SUBJECT: GRAND GULF NUCLEAR STATION, UNIT 1 - STAFF ASSESSMENT OF INFORMATION PROVIDED PURSUANT TO TITLE 10 OF THE *CODE OF FEDERAL REGULATIONS* PART 50, SECTION 50.54(f), SEISMIC HAZARD REEVALUATIONS FOR RECOMMENDATION 2.1 OF THE NEAR-TERM TASK FORCE (NTTF) REVIEW OF INSIGHTS FROM THE FUKUSHIMA DAI-ICHI ACCIDENT AND STAFF CLOSURE OF ACTIVITIES ASSOCIATED WITH NTTF RECOMMENDATION 2.1, "SEISMIC" (TAC NO. MF3750)

STAFF ASSESSMENT BY THE OFFICE OF NUCLEAR REACTOR REGULATION

RELATED TO SEISMIC HAZARD AND SCREENING REPORT

GRAND GULF NUCLEAR STATION, UNIT 1

Figure 3.3-1 Plot of Staff's and Licensee's Base Case Shear-Wave Velocity Profiles for the GGNS Site

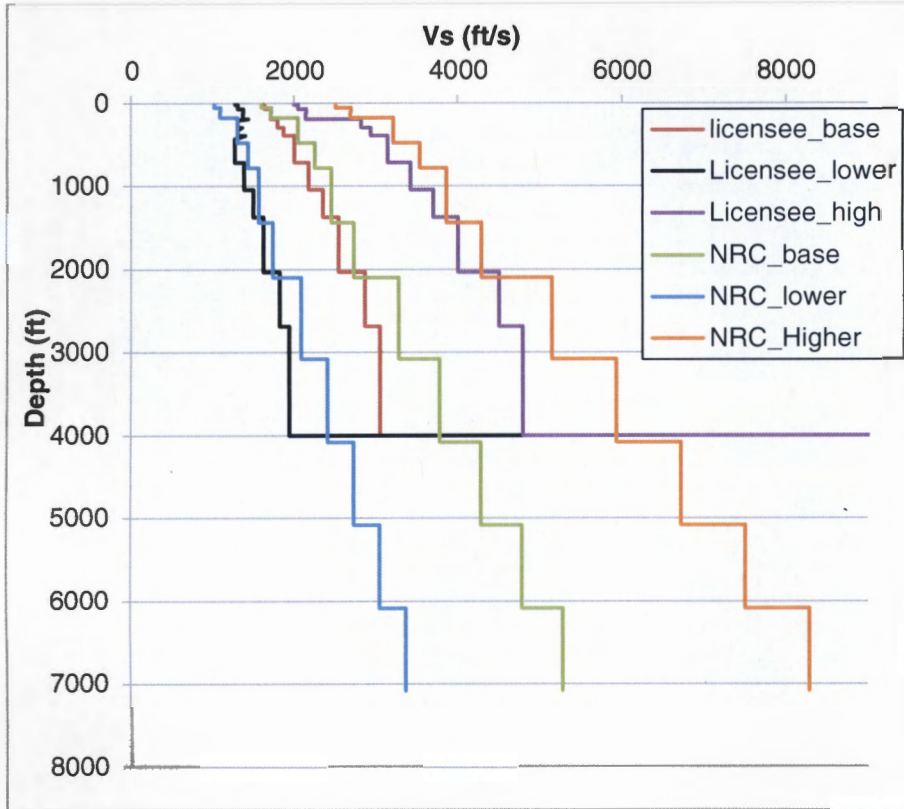
terminated its profile at 4,000 ft. (1,219 m) because shear wave velocity variations at depths greater than 4,000 ft. (1,219 m) are expected to have little impact on the site response at frequencies above the 0.5 Hz minimum defined by the GMM. To capture the uncertainty in the subsurface shear wave velocities, the licensee developed lower and upper base case velocity profiles using a scale factor of 1.25 over the upper 190 ft. (58 m) and a scale factor of 1.57 over the remainder of the profile. These values are consistent with a natural log standard deviation of 0.2 and 0.35 for the upper and lower portions of the profiles, respectively. Figure 3.3-1 of this assessment shows the licensee's three base case shear-wave velocity profiles.

To confirm the licensee's site response analysis, the NRC staff performed its own confirmatory calculations to independently test the licensee's calculations following the guidance in Appendix B of the SPID. The NRC staff developed a shear wave velocity profile, damping values and modeled nonlinear behavior of the subsurface materials using geological information and measurements provided in the GGNS UFSAR, the Early Site Permit (ESP) Site Safety Analysis Report (SSAR) (Entergy, 2005) for the Grand Gulf site, and Appendix B of the SPID. For its site response calculations, the NRC staff employed the RVT approach and developed input ground motions in accordance with Appendix B of the SPID.

The GGNS site condition is relatively well characterized due to the extensive geotechnical work implemented during subsurface investigations conducted as part of the ESP application. Geotechnical investigations included the drilling of boreholes, P-S logging, resonant column and torsional shear (RCTS) analyses, and other geotechnical studies of the shallow subsurface. Additionally, the ESP applicant correlated this new data with data collected during initial licensing of the operating plant, demonstrating consistency in the subsurface between the two sites. As a result, the NRC staff relied on UFSAR data, obtained during original licensing, to develop the shear wave velocities for the upper portion of the profile and used ESP data to extend the site profile to about 3,000 ft. (914 m) depth. The NRC staff extended the profile to a total depth of 7,000 ft. (2,134 m) using the shear wave velocity gradient recommended in the SPID. Specifically, the upper 200 ft. (61 m) of the shear wave velocity profile is based on UFSAR Table 2.1-6.6 and the remainder of the profile is based on Figure 2.5-61 of SSAR of the ESP application. To account for the variability in shear wave velocities beneath the site, the NRC staff developed lower and upper profiles using a natural log standard deviation of 0.2. Figure 3.3-1 of this assessment shows a comparison of the three base case profiles developed by the licensee with those developed by the NRC staff. The profiles developed by the NRC staff are generally similar to those developed by the licensee over the total depth of the profile. Differences between the two sets of profiles result from the staff's use of a slightly higher velocity gradient and the total thicknesses of the profiles as the profiles developed by the NRC staff extend to a greater depth than those developed by the licensee.

Figure 3.3- 2 Plot Comparing the Staff's and the Licensee's Median Amplification Functions and Uncertainties for the GGNS site.

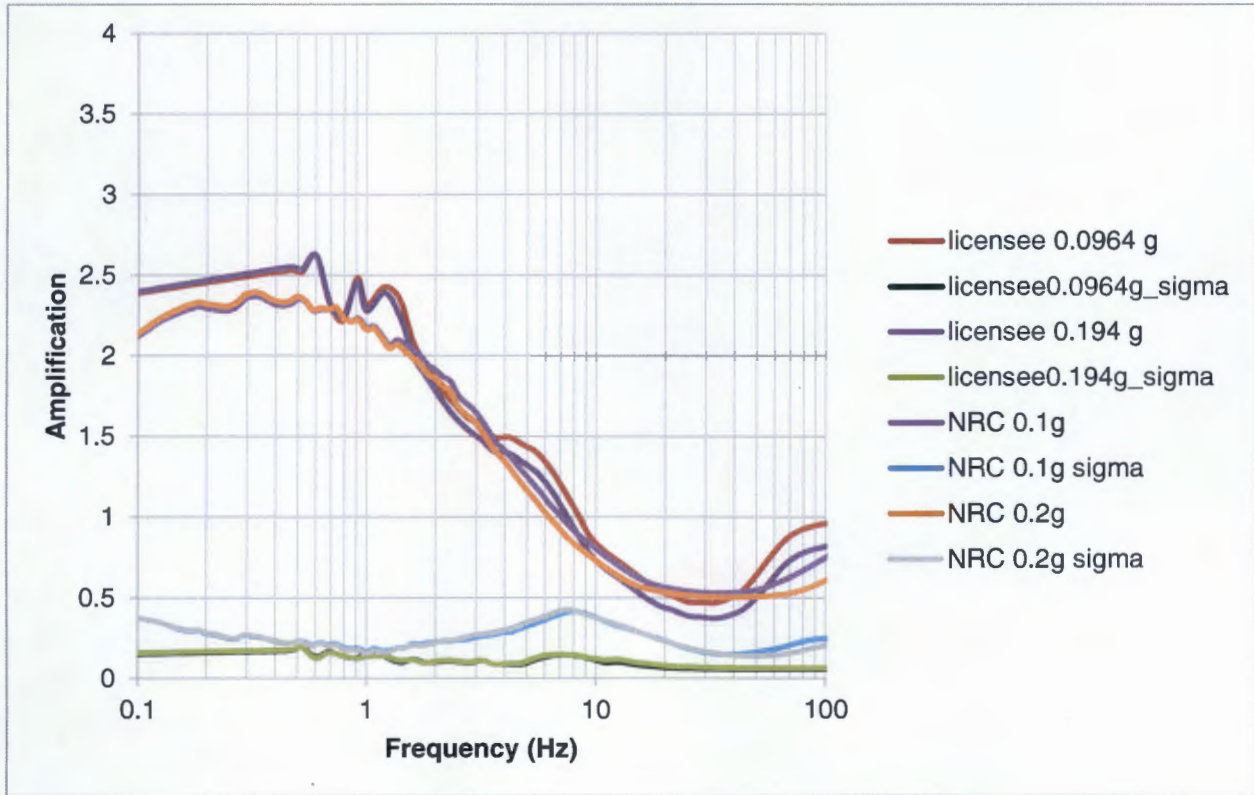
Figure 3.3-2 of this assessment shows a comparison of the staff's and the licensee's median site amplification functions and uncertainties (± 1 standard deviation) for two of the eleven input loading levels. Amplification functions developed by the NRC staff and by the licensee peak at a value of 2-2.5 between 0.1 to 1 Hz. Differences in the site amplification curves developed by the NRC staff and the licensee are very minor and are due to the minor differences in the site velocity profiles. As shown in Figure 3.3-3 of this assessment, these differences, and differences in PSHA inputs have a modest impact on control point seismic hazard curves and the resulting GMRS, discussed below. Appendix B of the SPID provides guidance for performing site response analyses, including capturing the uncertainty for sites with less subsurface data. However, the guidance is neither entirely prescriptive nor comprehensive. As such, various approaches in performing site response analyses, including the modeling of uncertainty, are acceptable for the 50.54(f) response.

Figure 3.3-3 Plot Comparing the Staff's and the Licensee's Mean Control Point Hazard Curves at a Variety of Frequencies for the GGNS site

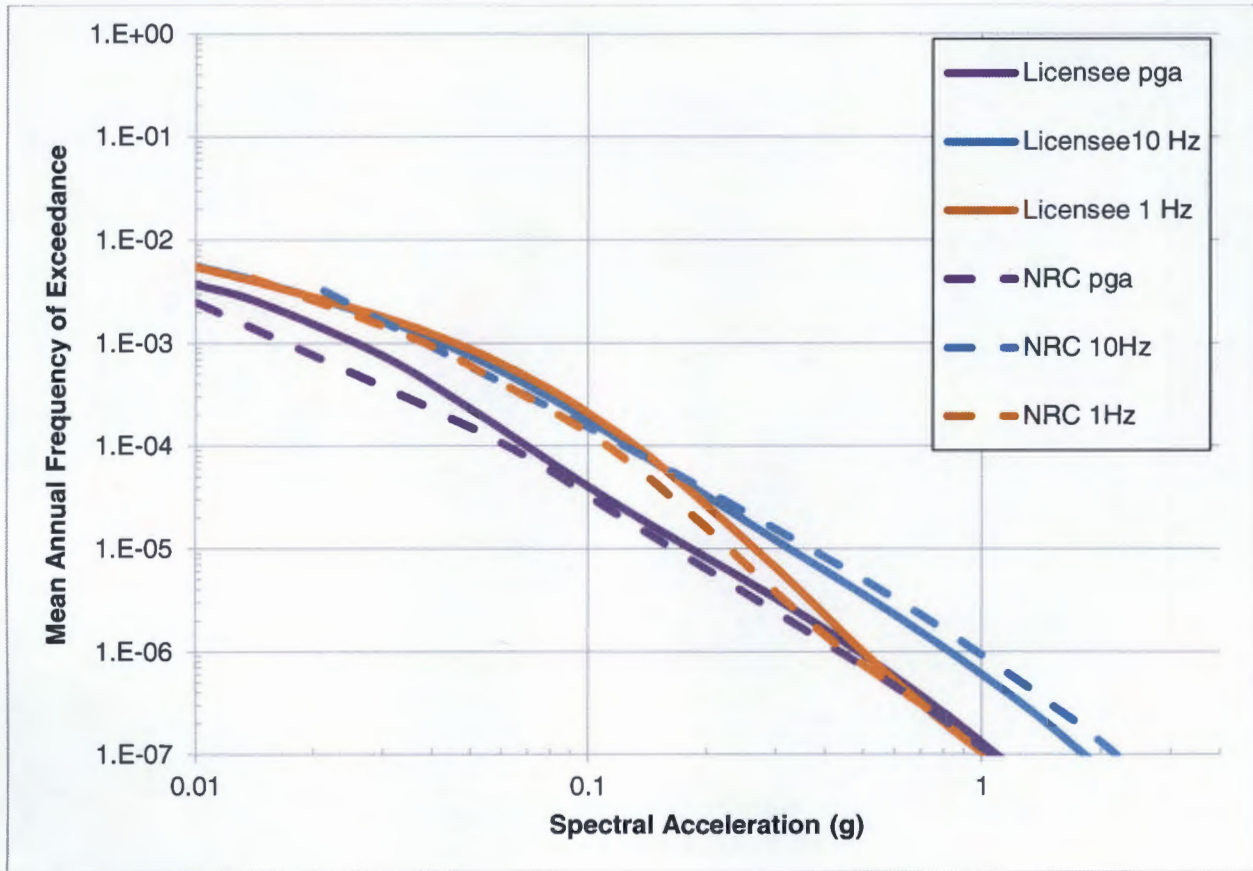
In summary, the NRC staff concludes that the licensee's site response was conducted using present-day guidance and methodology, including the NRC-endorsed SPID. The NRC staff performed independent calculations to confirm that the licensee's amplification factors and control point hazard curves adequately characterize the site response, including the uncertainty associated with the subsurface material properties, for the GGNS site.

Figure 3.4-1 Comparison of the Staff's GMRS with Licensee's GMRS and the SSE for the GGNS site

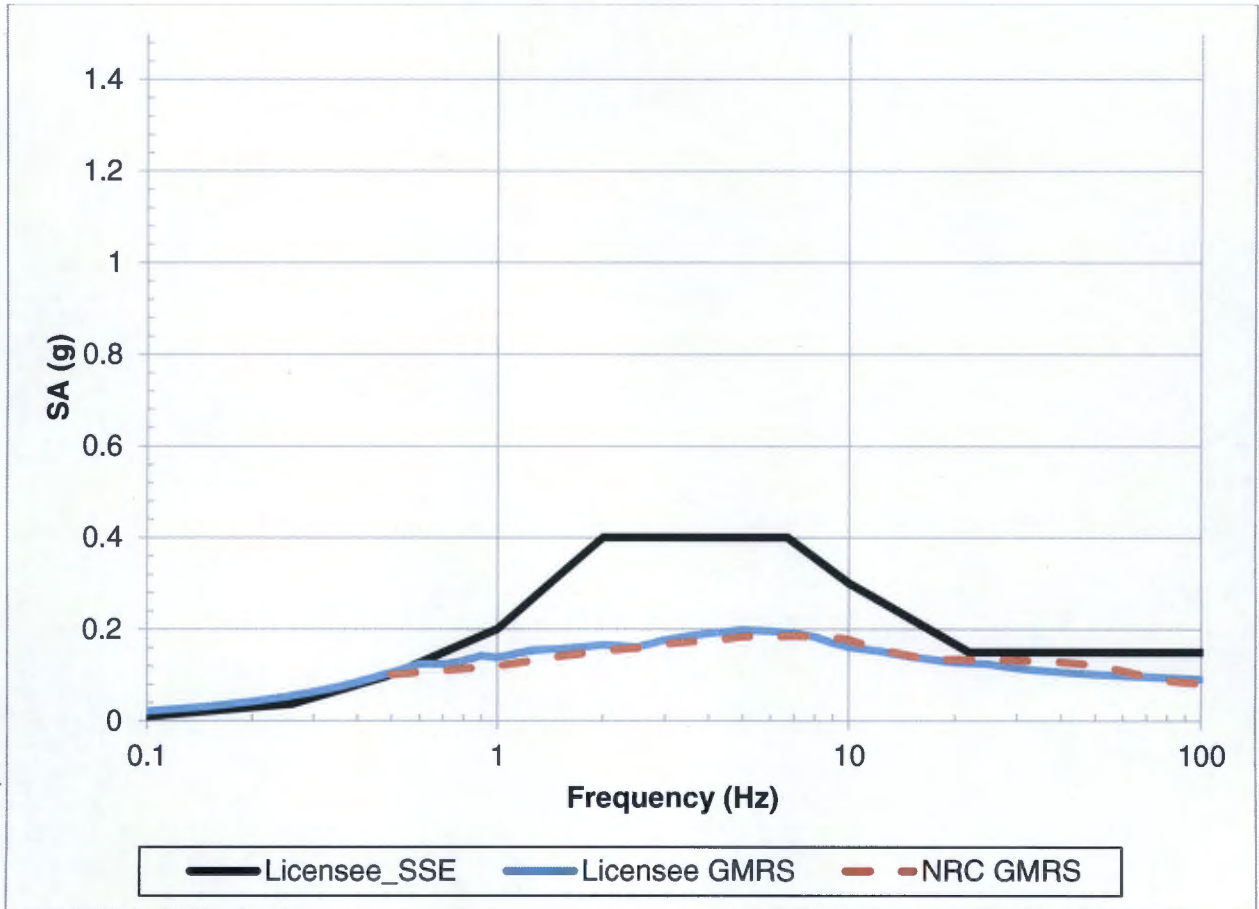
As shown in Figure 3.4-1 of this assessment, the licensee's GMRS shape is very similar to that calculated by the NRC staff. At frequencies where the amplitude of the GMRS determined by the licensee is different from that determined by the NRC staff, the licensee's generally exceeds that of the NRC staff. These differences in GMRS are the result of differences in the site response analyses and in the PSHA performed by the licensee and NRC staff, as discussed above.

The NRC staff confirms that the licensee used the present-day guidance and methodology outlined in RG 1.208 and the SPID to calculate the horizontal GMRS, as requested in the 50.54(f) letter. The NRC staff performed both a PSHA and site response confirmatory analysis and achieved results consistent with the licensee's horizontal GMRS. As such, the NRC staff concludes that the GMRS determined by the licensee adequately characterizes the reevaluated hazard for the GGNS site. Therefore, this GMRS is suitable for use in subsequent evaluations and confirmations, as needed, for the licensee's response to the 50.54(f) letter.
